10/825,462

Office Action Summary

CHIEH, CHO TSUNG

Lauren Nguyen

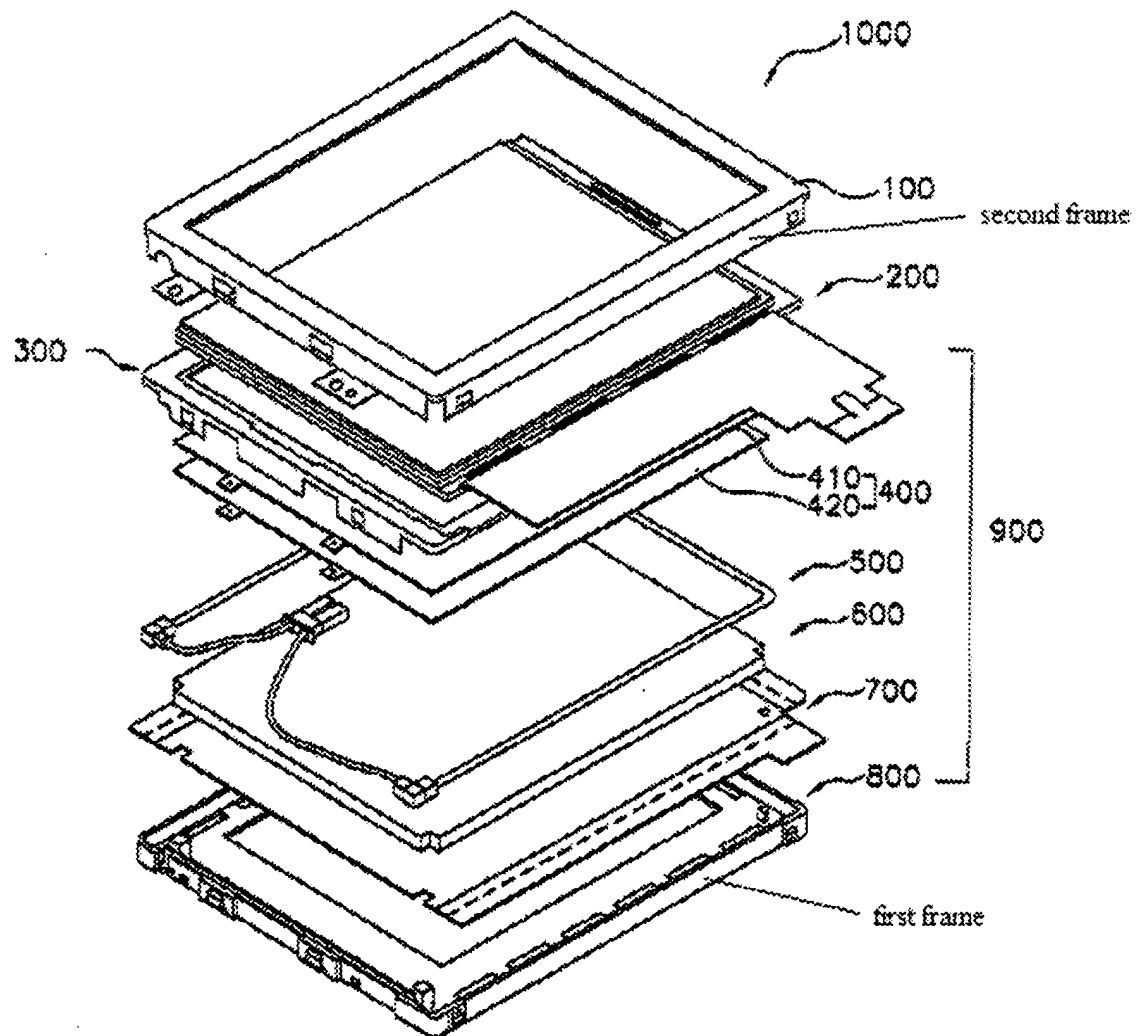
1. With respect to **claim 1**, as shown in figures 1-7, **Lee et al.** discloses a liquid crystal display module, comprising:

- a liquid crystal display body (200, figure 1);
- a base (800) having a first frame (810-816);
- a cover (100) having a second frame for covering said base through an engagement between said first frame and said second frame (see the drawing below);
- a plurality of mounting openings (121-126) mounted on an outer wall of said second frame;
- a plurality of indentations (127-128) positioned at a bottom surface of said second frame;
- a plurality of protrudent elements (871a-876a) mounted on an outer wall of said first frame and having positions corresponding to those of said plurality of mounting openings

for being engaged with said plurality of mounting openings so as to secure said engagement between said first frame and said second frame (see at least paragraph 0079, lines 8-18 and paragraph 0080, lines 1-6); and

- a plurality of blocking elements (878-879) mounted at a bottom surface of said first frame and having positions corresponding to those of said plurality of indentations for preventing said bottom surface of said second frame from being pressed over said bottom surface of said first frame (see at least paragraph 0080, lines 6-11).

- a liquid crystal display body (200, figure 1);
- a base (800) having a first frame (810-816);
- a cover (100) having a second frame for covering said base through an engagement between said first frame and said second frame (see the first drawing);

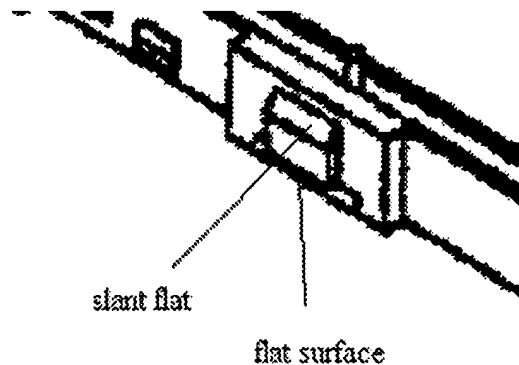
5. With respect to **claim 3**, as shown in figures 1-7, **Lee at al.** discloses upper surfaces of said plurality of protrudent elements (871a-876a) are slant flats (see the drawing below) so as to help said plurality of protrudent elements to protrude through said plurality of mounting openings (121-126) when said first frame is engaged with said second frame.

6. With respect to **claim 4**, as shown in figures 1-7, **Lee at al.** discloses bottom surfaces of said plurality of protrudent elements (871a-876a) are flat surfaces so as to prevent said first frame from being disengaged from said second frame (see the drawing below).

10. With respect to **claim 9**, as shown in figures 1-7, **Lee at al.** discloses said plurality of protrudent elements (871a-876a) have horizontal positions higher than those of said blocking elements (878-879, see the drawing below).
